Subject: Duke Energy Carolinas, LLC (Duke Energy)
Catawba Nuclear Station, Units 1 and 2
Docket Numbers 50-413 and 50-414
Response to Request for Additional Information Regarding Overall
Integrated Plan in Response to Order EA-12-051, "Reliable Spent Fuel
Pool Instrumentation"
(TAC Numbers MF1060 and MF1061)

REQUEST FOR ADDITIONAL INFORMATION
OVERALL INTEGRATED PLAN IN RESPONSE TO
ORDER EA-12-051, "RELIABLE SPENT FUEL POOL INSTRUMENTATION"

CATAWBA NUCLEAR STATION, UNITS 1 AND 2

FIGURE 1

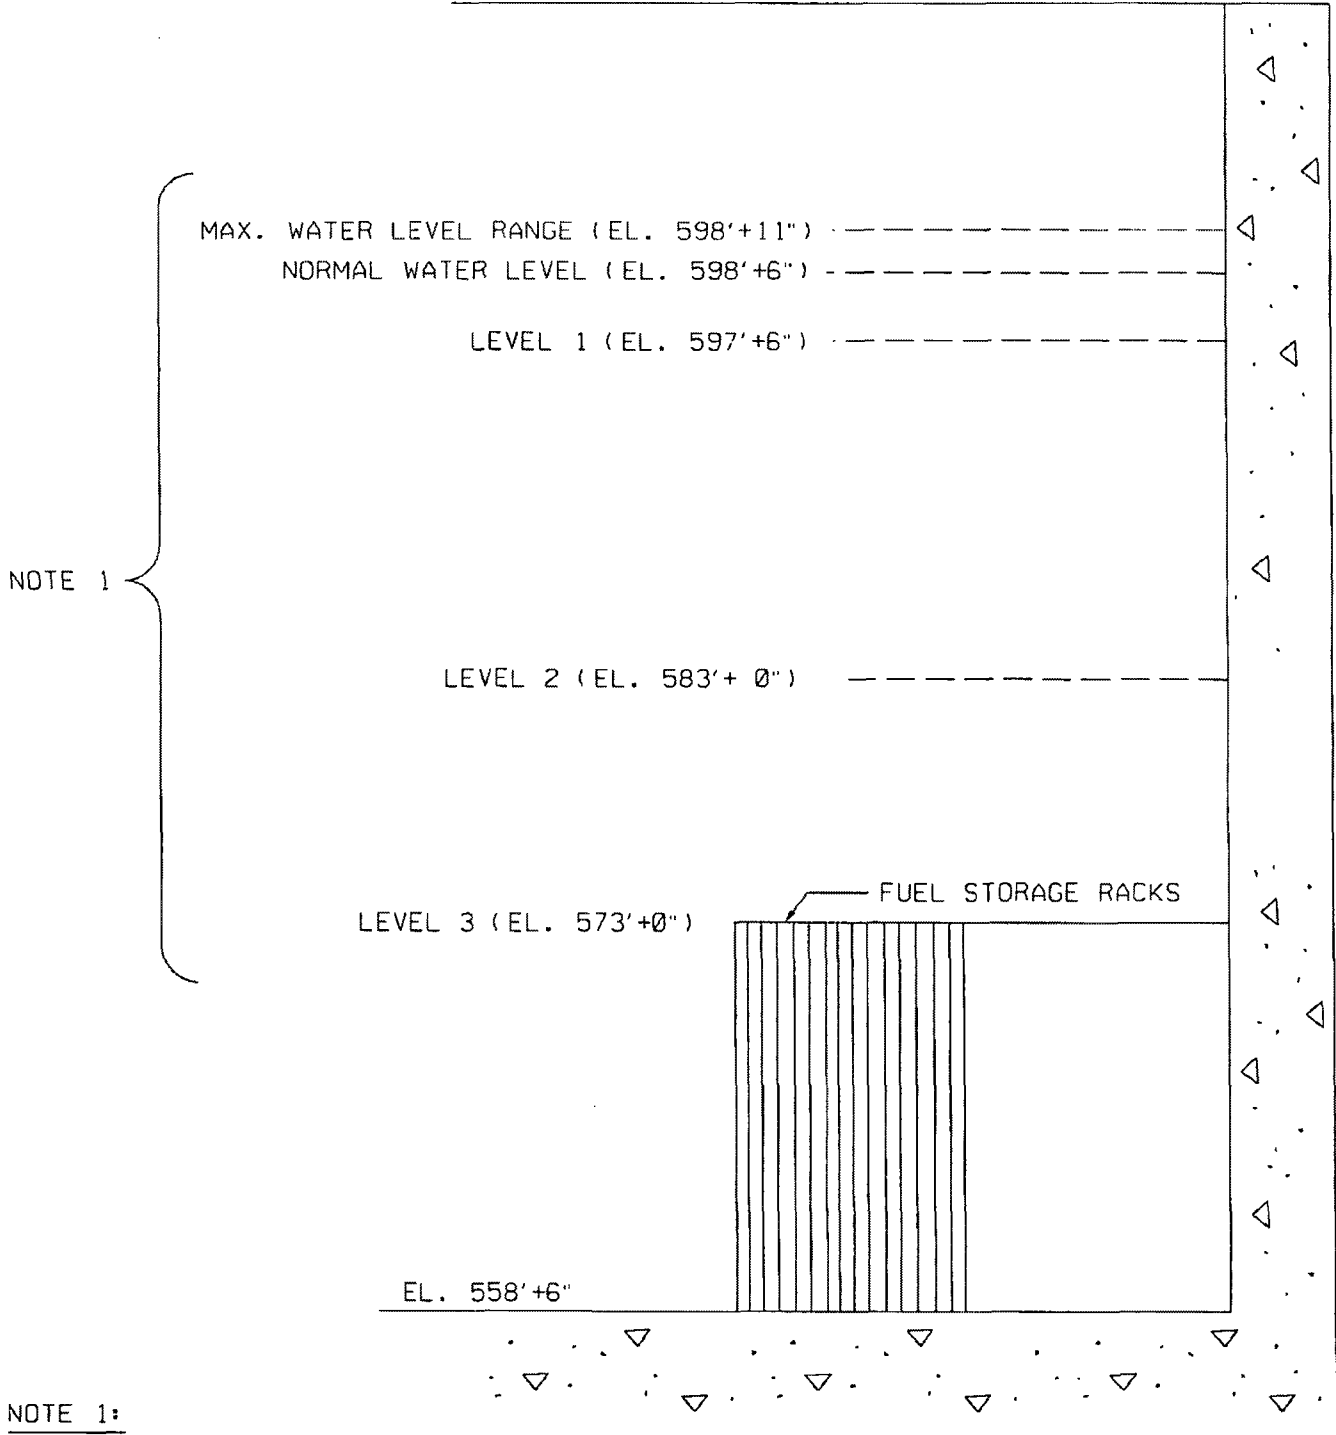
- a) For level 1, specify how the identified location represents the HIGHER of the two points described in the NEI 12-02 guidance for this level.
- b) A clearly labeled sketch depicting the elevation view of the proposed typical mounting arrangement for the portions of instrument channel consisting of permanent measurement channel equipment (e.g., fixed level sensors and/or stilling wells, and mounting brackets). Indicate on this sketch the datum values representing Level 1, Level 2, and Level 3 as well as the top of the fuel. Indicate on this sketch the portion of the level sensor measurement range that is sensitive to measurement of the fuel pool level, with respect to the Level 1, Level 2, and Level 3 datum points.

- b) The radar level instrument design will locate components in the SFP area such that they will remain above the maximum water level in the SFP, and the equipment mounts will not require any connections to be made to the pool liner. The mounting brackets for the wave guided assemblies and receiving horns will be secured to the SFP operating deck which is at 605'-10" elevation (reference drawing CN-1680-0123, Revision 6). The specific installation locations for the wave guided assemblies and receiving horns have not been finalized. Additional information on equipment elevation, equipment orientation, and mounting for both the primary and the backup channel devices will be included in the response to RAI-2. Figure 1 at the end of this attachment provides the elevations representing Level 1, Level 2, and Level 3, the top of the fuel storage racks, and the level monitoring range.
